14MP
14 Milton Place
Gravesend
DA12 2BT
Kent

Interior refurbishment
Listed Building Consent 20250269

14MP09/PR Rev.2

Status: Discharge of planning conditions

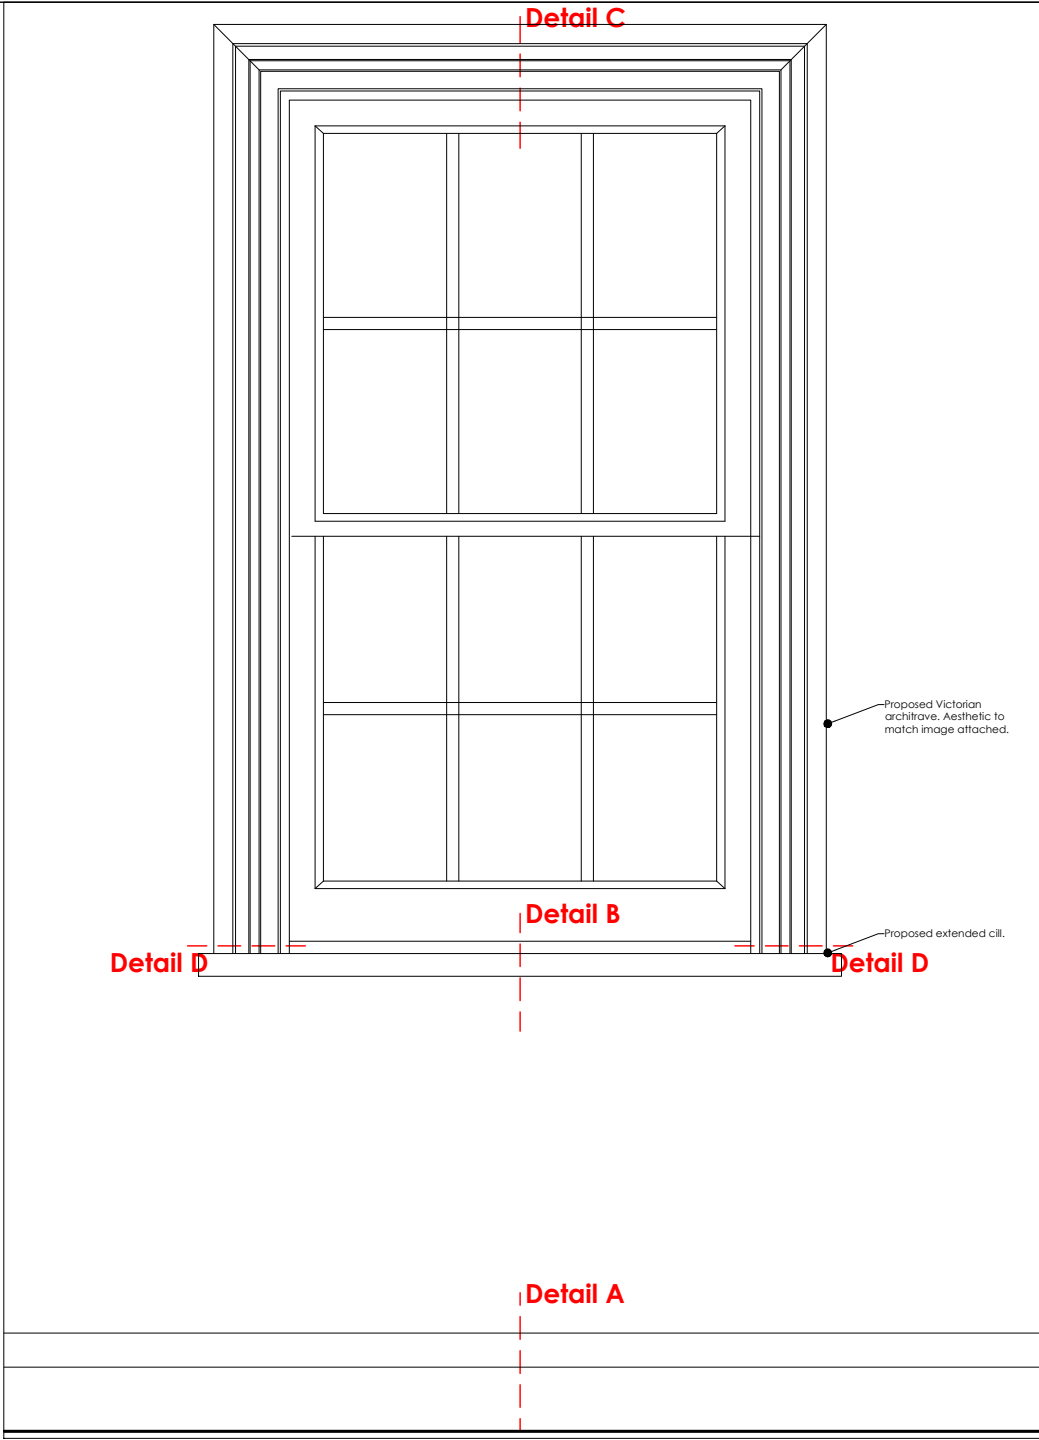
10/07/2025 - Rev.1
-Window's reveals adjusted by extending the window sill and reveal board with an Victorian architrave.
-Proposed new Victorian skirting board , as per planners' suggestion.

23/07/2025 - Rev.2
-Windows architraves' setting amended as per planners' request.
Architrave to be added also to Bedroom 2, 4 and Reception room.

The Thermaline Plus insulation is not proposed in the kitchen, therefore the package to run the electric cabling is proposed to be provided with plasterboard.
